Waikato Regional Council

Technical review of the

*Raglan Wastewater Treatment Plant Discharge
Assessment* report as prepared by DHI for BECA

February 2020

Figure 2.1 Comparison between measured and modelled depth-averaged current velocities at peak flood (left) and peak ebb (right) at the section A.

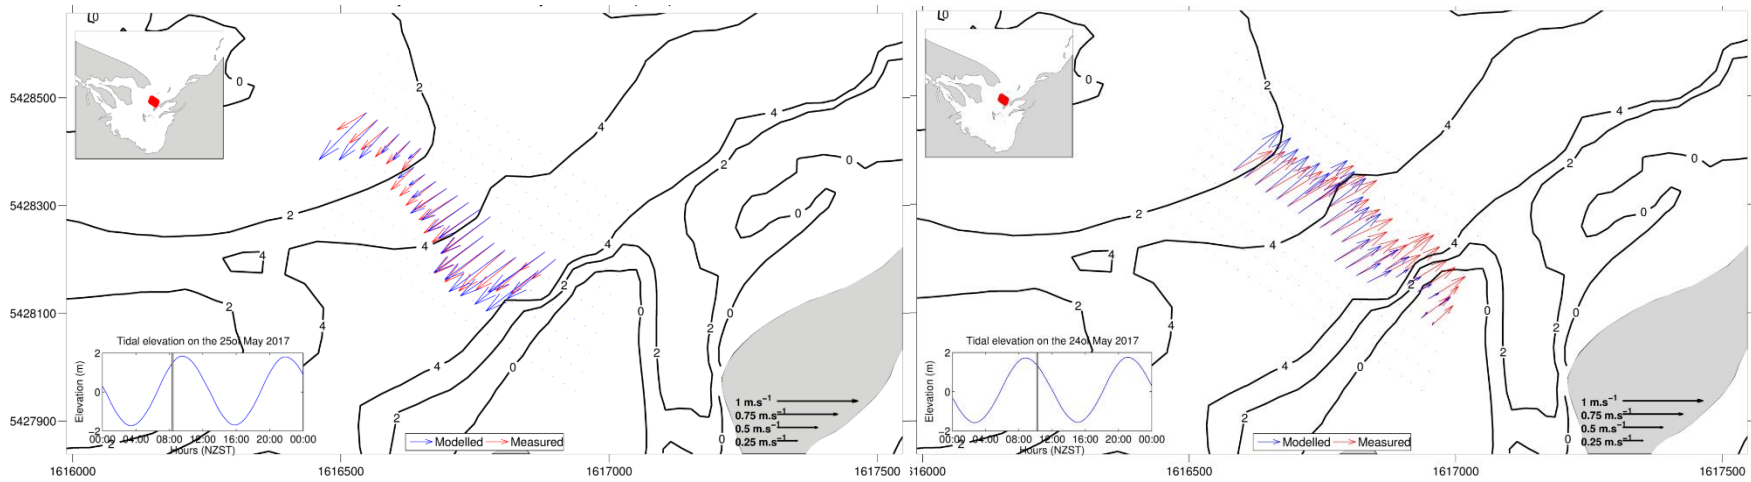
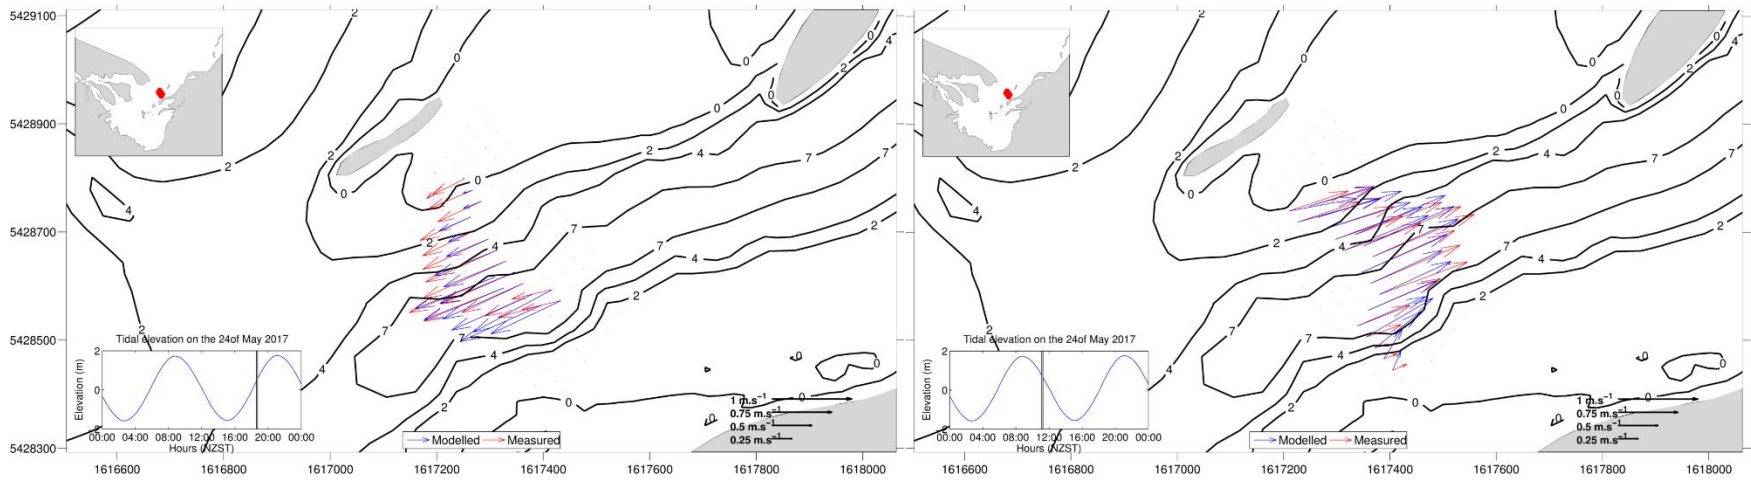
Oldman (2019) has applied a semi-quantitative validation approach by considering measured depth averaged speed data from the ADCP transects and co-locating model data for the same time. Comparisons between the modelled and measured data, given this processing step, suggests that, when taking into consideration all the potential errors, the model does and ok job at predicting the channel hydrodynamics, though the RMSE is relatively high at 0.18 m.s⁻¹. It would have been useful to see a comparison between the model predicted and measured current velocities (as opposed to speed) to ensure that the model was adequately predicting the current velocities within the channel (e.g. Figure 2.1 and Figure 2.2).

- A semi-quantitative validation is presented, suggests that, given all the likely uncertainties, the model does an ok job at predicting the channel hydrodynamics all be it with a relatively high RMSE of 0.18 m.s⁻¹.

Figure 2.3 Measured inflow and outflow from the Raglan waste water treatment plant (daily values).

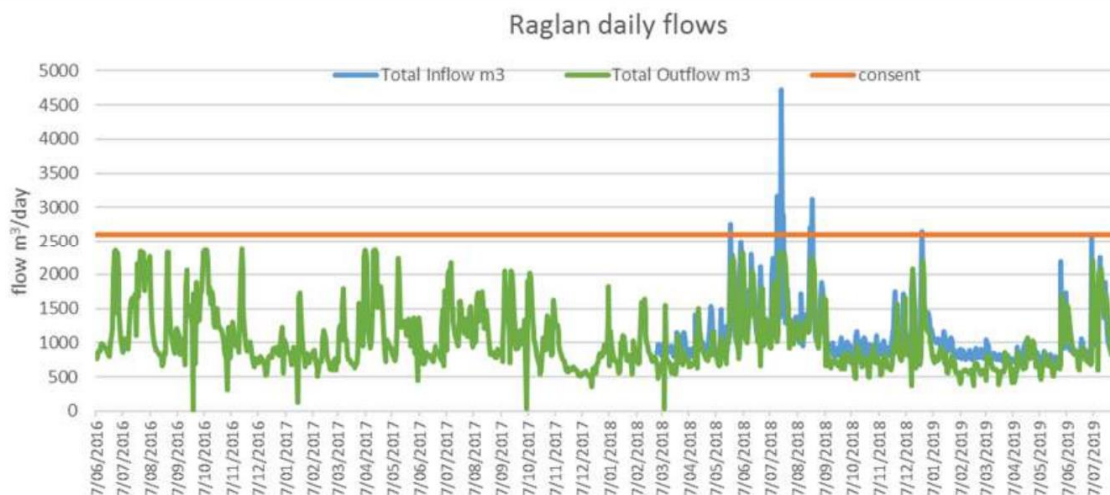
The report presents only average discharge velocities of wastewater associated with a mean daily discharge (of 1175 m³.day⁻¹) and a median discharge duration (2 hr and 15 min), i.e. 0.06 m³.s⁻¹, while a projected peak summer flow is of the order 0.15 m³.s⁻¹ (Oldman 2019, Section 2, after Gibbs and Watson, 1996). The measured inflow and discharge outflow is for a period spanning 2016-2019 is presented in Figure 2.3 and show significant temporal variation in the daily average discharge volumes, with the previous consented discharge level significantly higher than results presented in the report (i.e. 2500 m³ per day consented vs 1175 m³ per day presented in the reports).

- Dilutions characteristics associated with only the mean daily discharge and a median discharge duration are presented. This is a significantly lower discharge volume that the previously consented values, and significantly less than predicted peak summer flows.

Figure 2.4 Schematic image from NIWA showing dispersion characteristics of dye offshore Whāingaroa/Raglan Harbour, and a general SE flow direction (after Oldman, 2019).

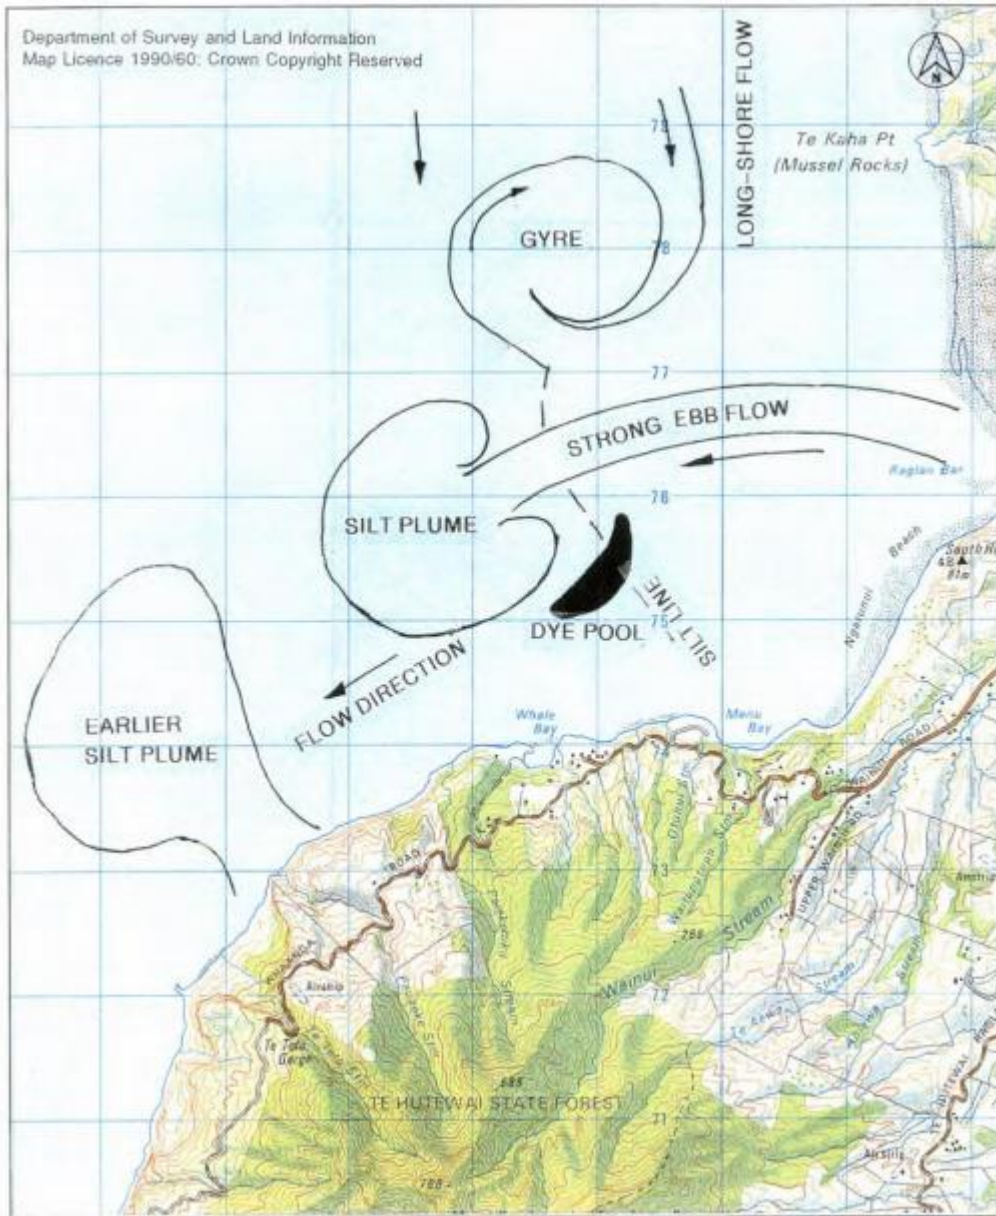
Oldman (2019) notes that the offshore currents outside the harbour from the modelling show a predominance of the northerly directed current direction and states that this is consistent with the observed dye test undertaken by NIWA and as provided in Appendix A of Oldman (2019). This appears to be an incorrect statement as they dye release observations and associated figures presented in Appendix A of Oldman (2019) clearly indicate a southeast directed current direction (see Figure 2.4), and also is apparent in various historical aerial images available on Google Earth (i.e. Figure 2.5). It is not clear if the hydrodynamic modelling undertaken captures these SE current velocities or not, and it would be interesting to determine under which climatic conditions they occur (assuming the modelling captures this process).

- Oldman (2019) notes that the offshore currents outside the harbour from the modelling show a predominance of the northerly directed current direction and states that this is consistent with the observed dye test undertaken by NIWA and as provided in Appendix A of Oldman (2019). This appears to be an incorrect statement (see Figure 2.4),

Figure 2.5 Aerial image of Whāingaroa/Raglan Harbour entrance illustrating the presence of a turbid plume extending SE from the harbour entrance.

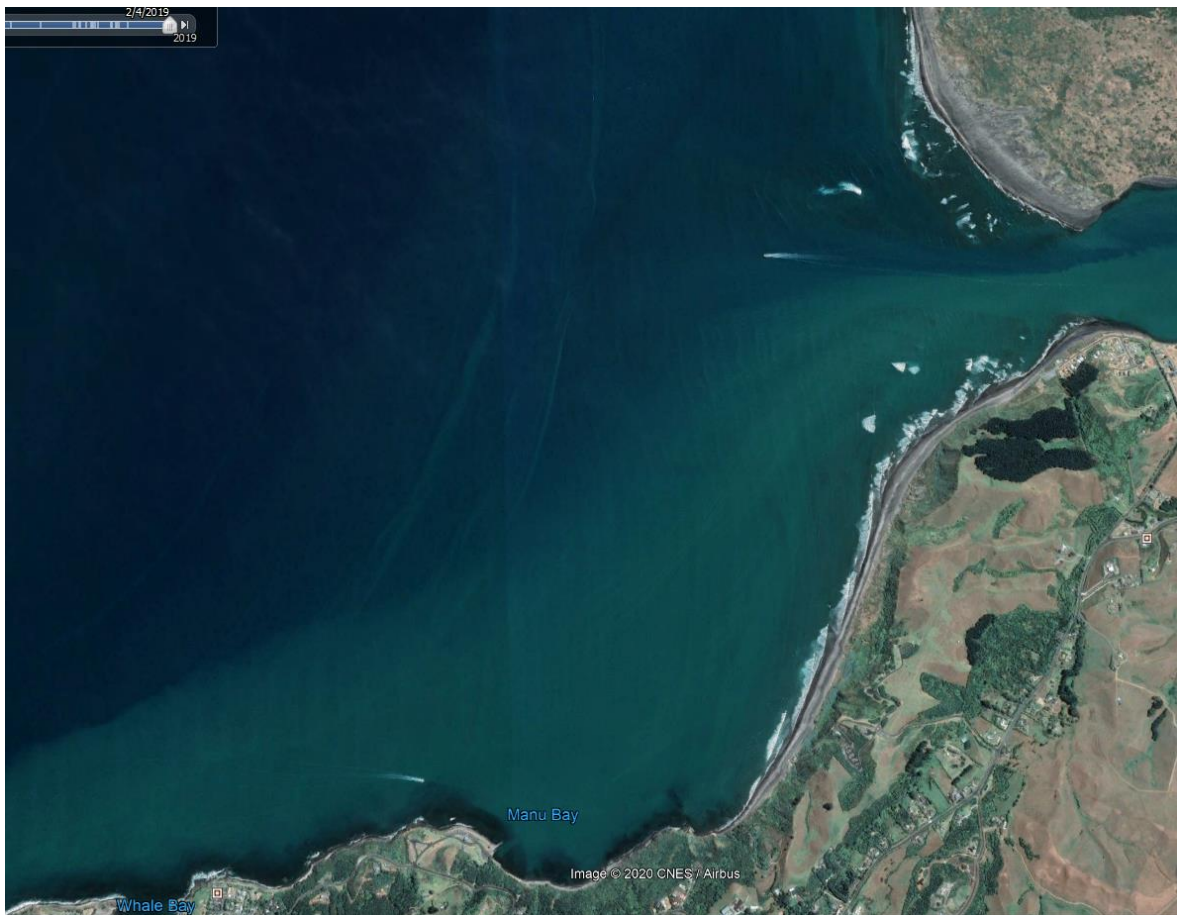
- It is not clear if the hydrodynamic modelling undertaken captures these SE current velocities.
- Oldman (2019) presents results for a future discharge volume based on an increase from 1175 m³ per day to 2335 m³ per day. These discharge volumes are based on mean daily discharges for the existing and a hypothetical future state/population.

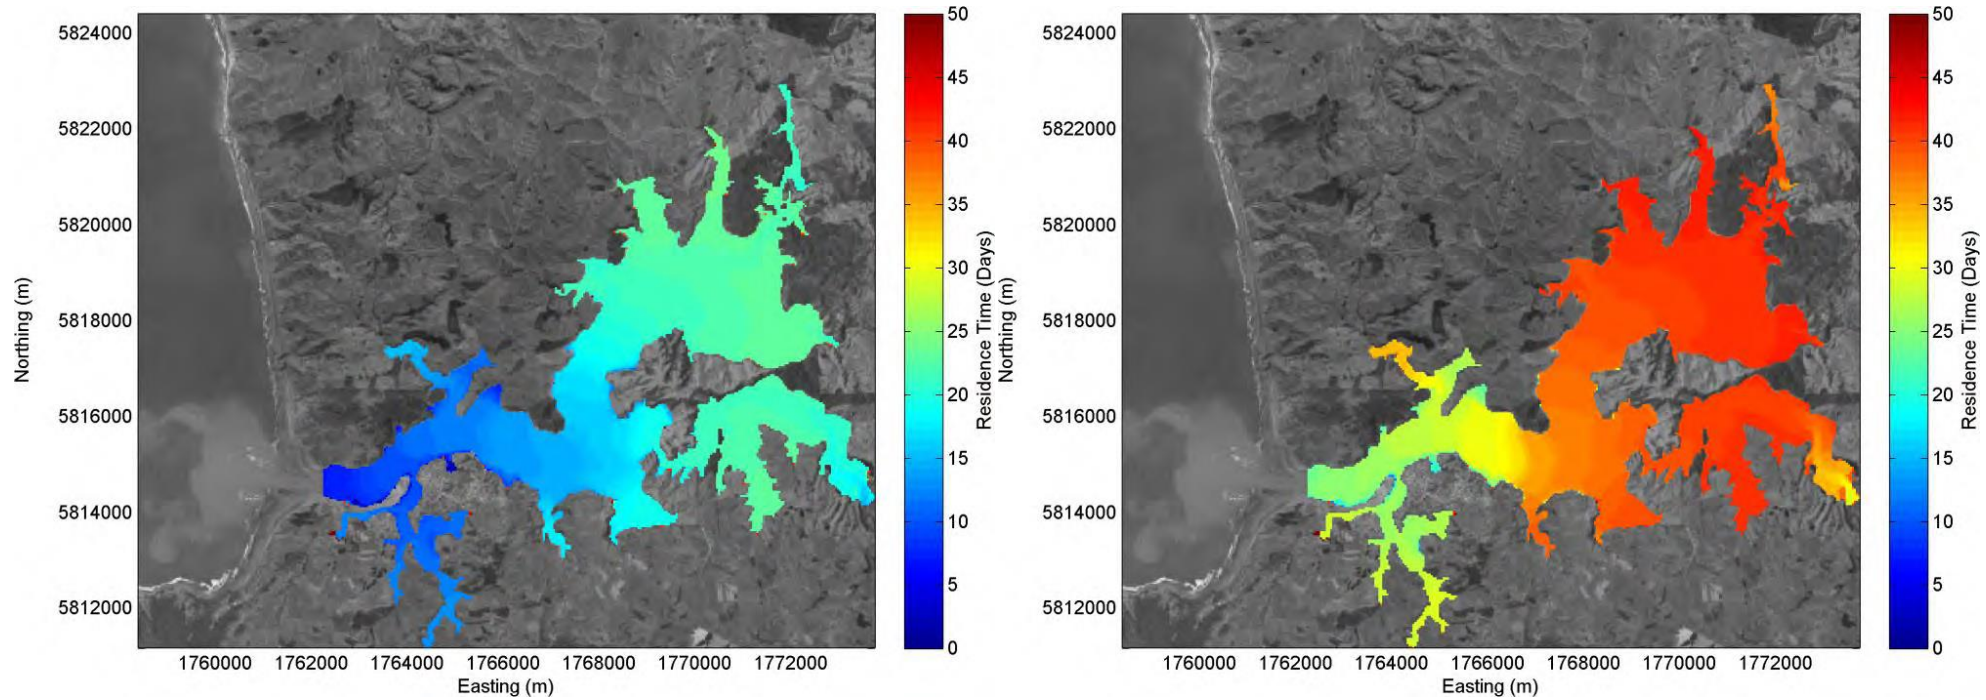
BECA, (2019) present a figure where a 20% threshold has been applied to infer the flushing of the cell (see BECA, (2019)), suggesting a dilution of 0.2 at which point the cell can be considered flushed. The 20% threshold as applied by Greer et al., (2016) was one of a range of thresholds used to illustrate the effect of choosing different thresholds, while the majority of the study presented results (including for Whāingaroa/Raglan Harbour) applied a threshold of 5%. To illustrate the potential differences in harbour wide residence times reproduced by BECA, (2019) and those reported in Greer et al., (2016) (at 5% threshold), the relevant model outcomes are presented in Figure 3.1 and illustrate that by choosing a higher threshold, residency times can appear significantly reduced. This highlights the importance of understanding the caveats as described above when applying the findings of Greer et al., (2016) beyond their intended use.

- BECA, (2019) also reference the report of Greer et al., (2016) and present a figure depicting residency times within the harbour. The figure presented is a figure used to examine the % threshold of defining a cell as being flushed or not, with a threshold of 20%, while throughout the report Greer et al., (2016) use a threshold of 5% predominantly.

- The significant differences between the 20% and 5% threshold result highlights the importance of understanding the caveats as defined within Greer et al., (2016) when applying the findings of Greer et al., (2016) beyond their intended use.
